SERVICE BULLETIN NO. MSB315-62/2

ATA-Code: N/A C of G release hook

G 103A/B/C

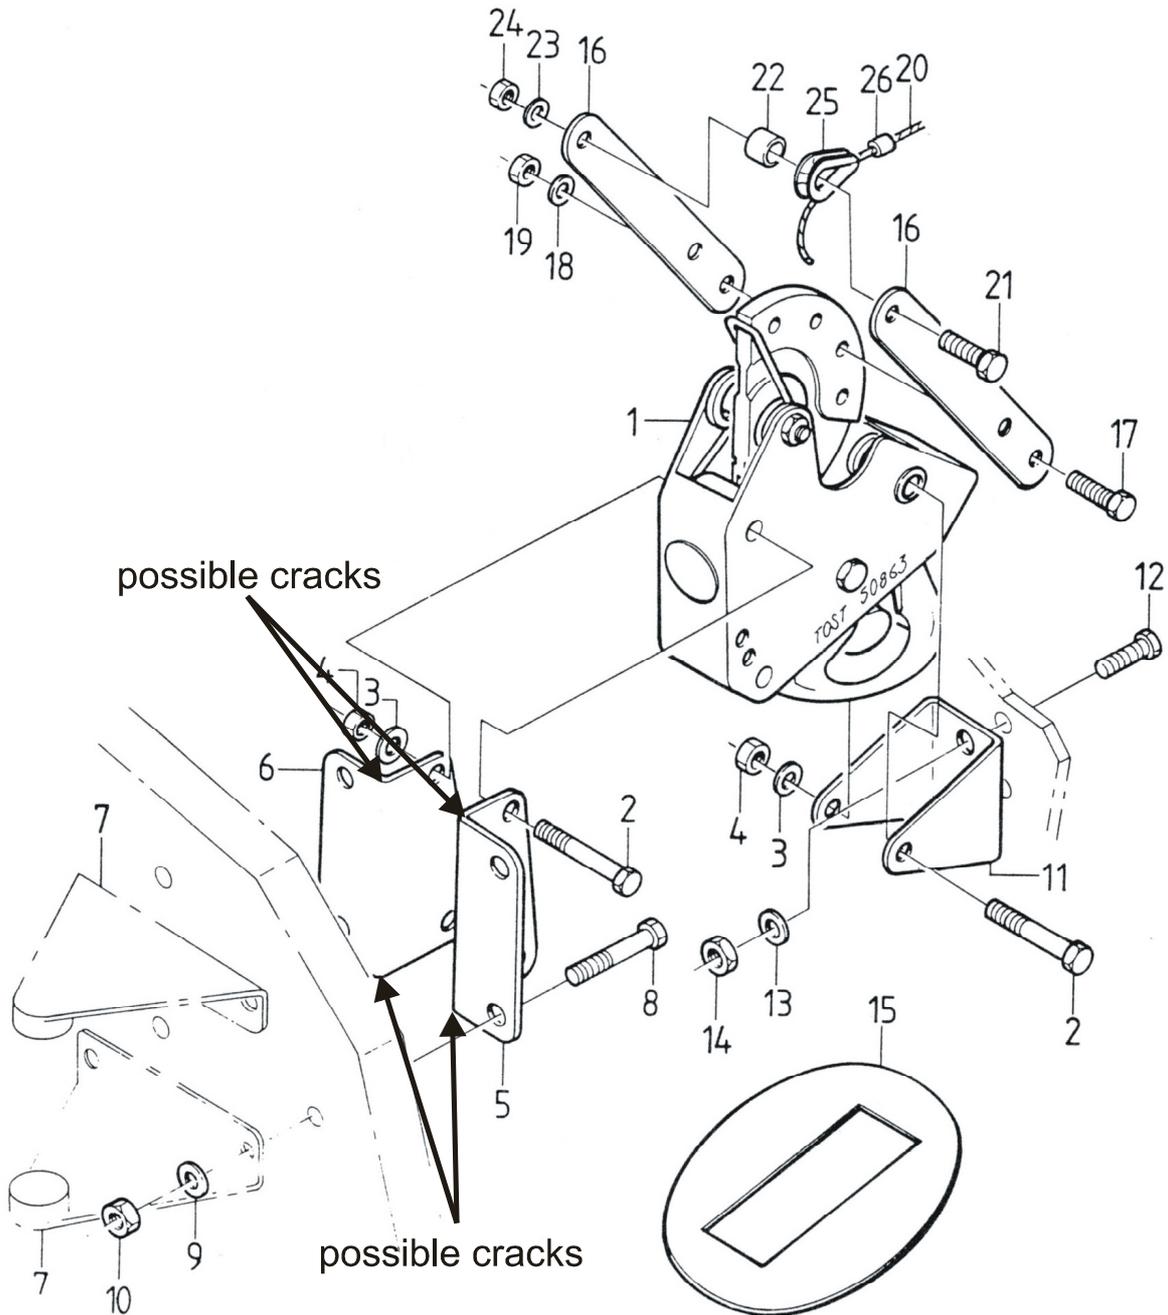
After long time of operation (i.e. towing using the C of G release hook) cracks at the forward C of G release hook attachment brackets might occur.

1.8.1 The attachment brackets P/N 103-2235.03 and 103-2235.04 or 103B-2360.01 and 103B-2360.02 must be checked for cracks as follows:

- remove rear seat
- check the brackets for possible cracks, refer to illustration on page 2 (if necessary use mirror and flash light)

1.8.2 Both forward C of G release hook attachment brackets must be replaced as follows:

- remove rear seat
- remove L/H and R/H instrument panel cover
- remove **front** attachment of the C of G hook (item 2, 3, 4), loosen rear attachment (item 12, 13, 14)
- remove attachment brackets (page 2, item 5 and 6)
- install new brackets P/N 103B-2360.01/2 and 103B-2360.02/2

Caution: On TWIN ASTIR and TWIN ASTIR TRAINER the additional plate P/N 103-2360.02 must be installed below the attachment brackets.
